ANCHOR #2

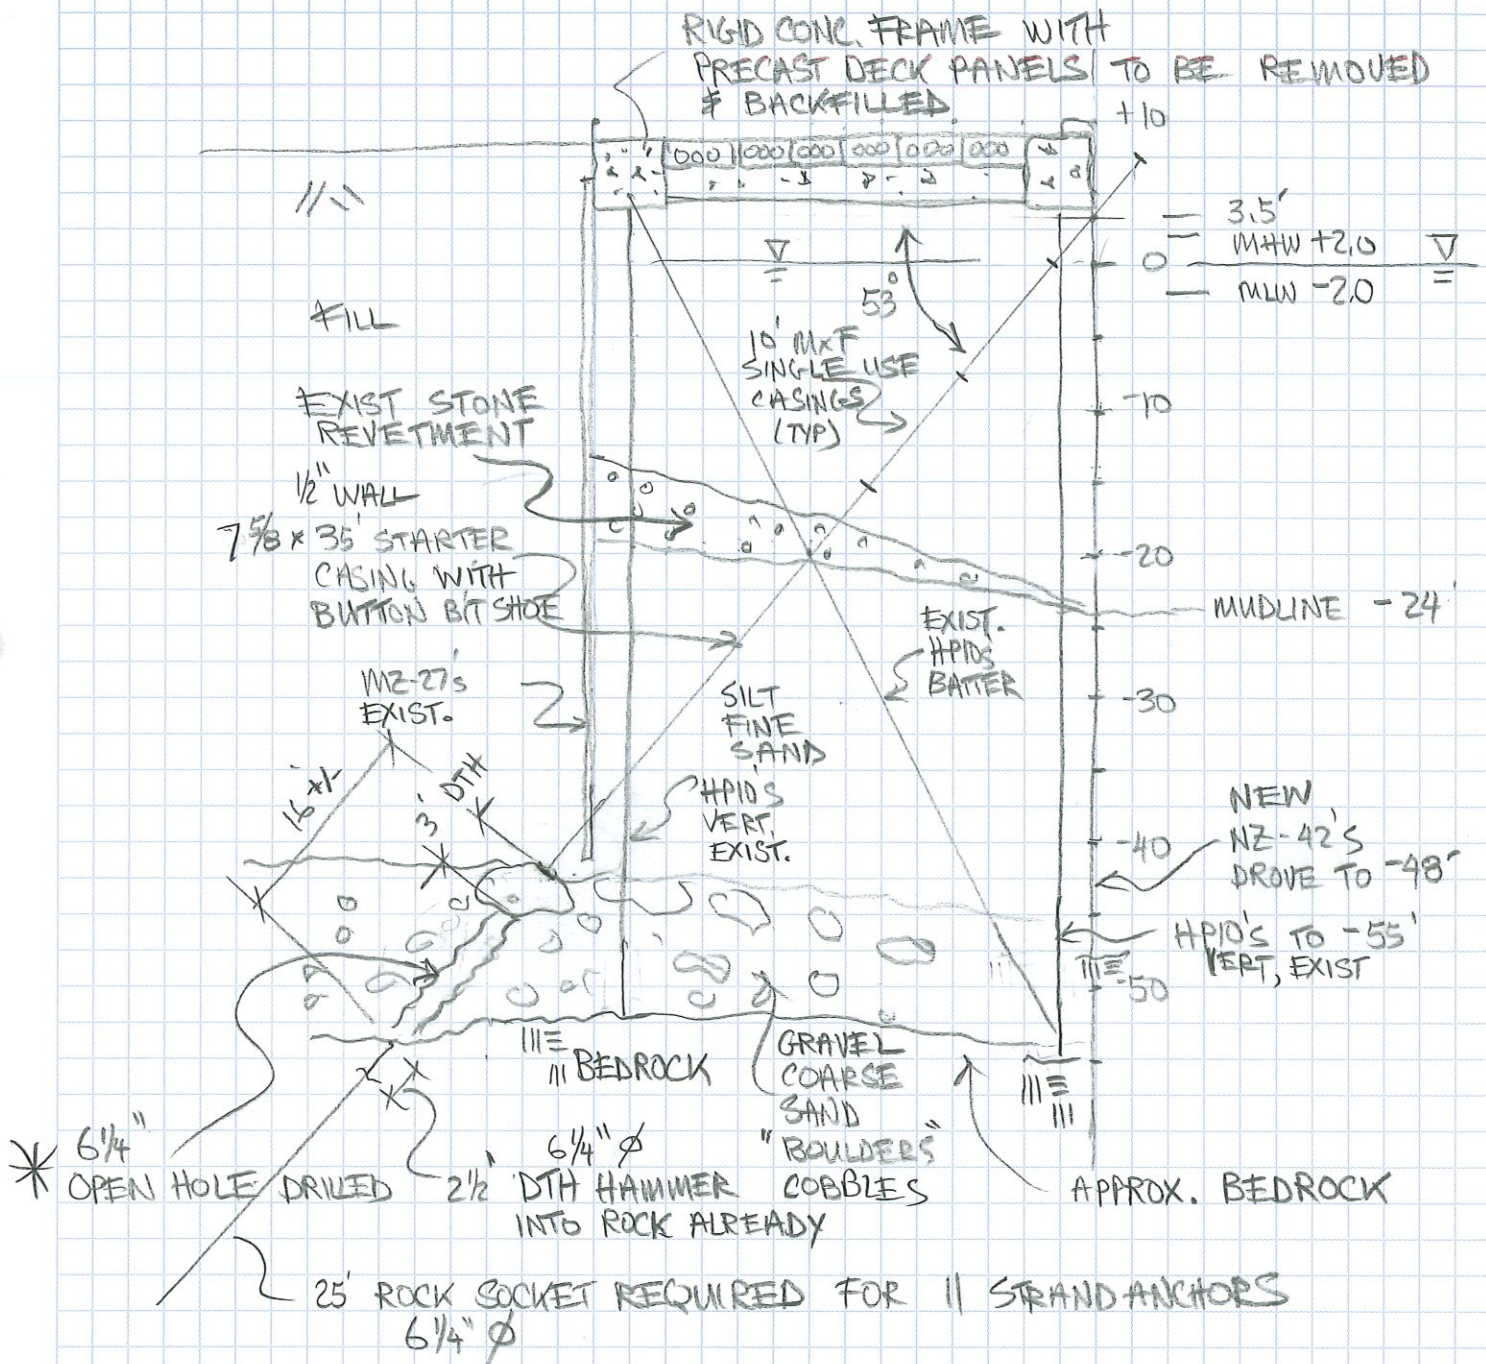
* WE HAVE TRIED TO GROUT THIS AREA 6 TIMES. IT STILL COLLAPSES ON US WHEN RE-HAMMERING. ANY SUGGESTIONS,

WE CAN'T TURN CASING ANYMORE, AFTER OUR 1ST GROUT ATTEMPT WE GROUTED IT IN.
